Strathfield Internal Development Assessment Panel Meeting

DA2019/066 - 37 Fraser Street, Strathfield

REPORT: IDAP – Report No. 1

Proposal: Demolition of the existing dwelling and construction of a new two (2) storey dwelling house with a cabana, and associated landscaping works.

Figure 9: A site plan detailing the trees on site where the trees proposed to be removed are highlighted in purple.

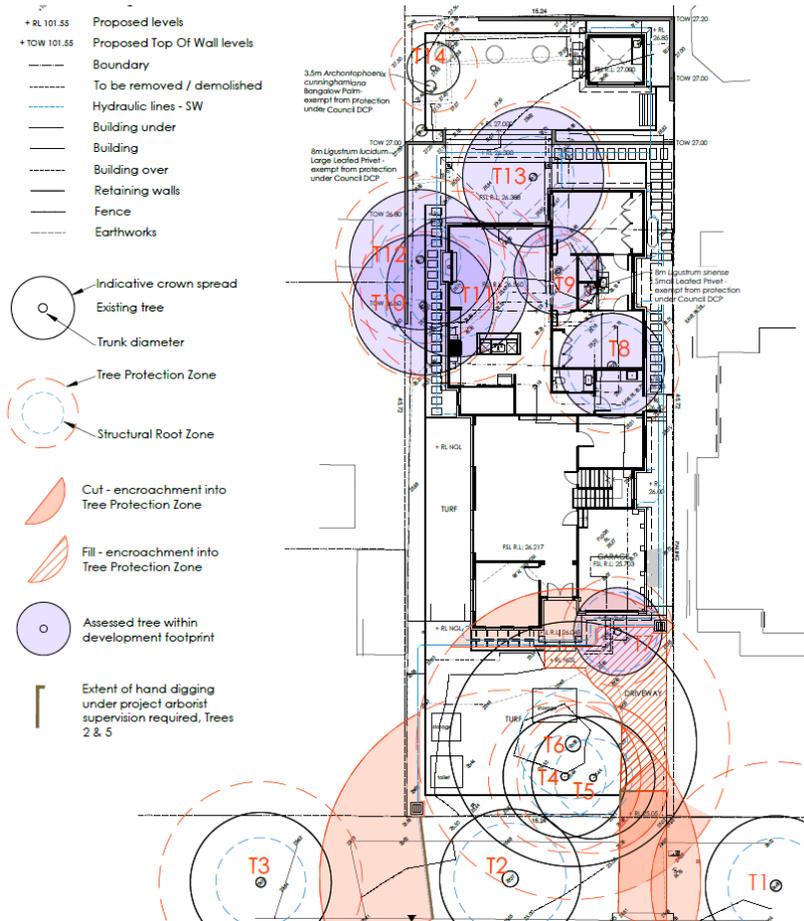
The submitted plans and Arborist report detail that trees no. 7 – 13 are proposed to be removed (Figure 9) as there is an unavoidable major encroachment into the tree protection zone and also tree no. 14 as it is of low significance. The submitted plans and Arborist report detail that tree nos 1-6 will be retained and protected (trees no. 1-3 are street trees and trees no. 4-6 are located within the front yard of the subject site) (Figure 9).

"The proposed demolition of existing dwelling and construction of a new two storey house, cabana and retaining walls will cause adverse impacts to significant trees within the front yard of the subject property that is not supported by tree management staff.

The applicant is to submit an amended design for the proposed driveway and stormwater service that will allow the successful retention of trees 4, 5 and 6 Corymbia citriodora.

The applicant is also required to provide a tree protection plan prepared by an AQF5 qualified consulting arborist detailing how all adverse impacts to the subject trees will be avoided during the works; tree management recommendations will have due regard for the provisions of the Australian Standard AS4970-2009, Protection of Trees on Development Sites."

Amended plans and additional information including a Tree Protection Plan was received and Council's Tree Management Officer advised that the Tree Management Plan is suitable for approval.

Council's Tree Management Officer has supported the amended Landscape Plan and the Tree Management Plan, subject to the imposing of recommended conditions of consent.

Figure 11: An extract of the rear of the dwelling house where the retaining walls are outlined in red.

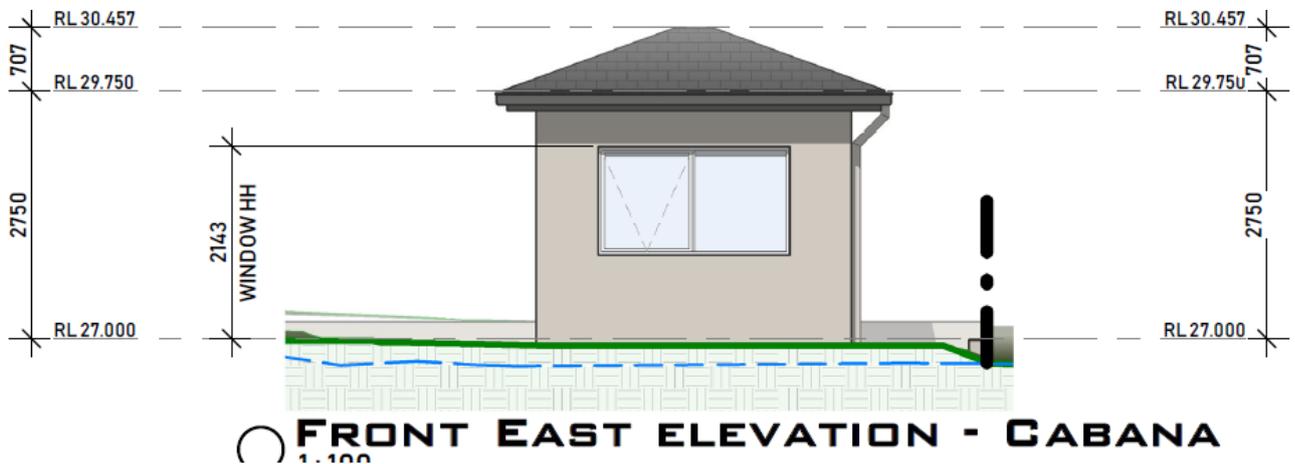
Retaining walls are sought along the southern boundary and at the rear of the site in order to create a flat turfed area and step down to the alfresco and dwelling. There are three (3) steps to the turfed area and a height difference of 0.62m. The retaining walls are in excess of 600mm, therefore a qualified practicing engineer is required to design and document the construction of the retaining walls (Condition 3).

Retaining walls which are in excess of 0.6m in height are to be fully designed and documented by a qualified practising engineer. Plans detailing the retaining wall are to be submitted to, and approved by the Principal Certifying Authority prior to issuing a Construction Certificate.
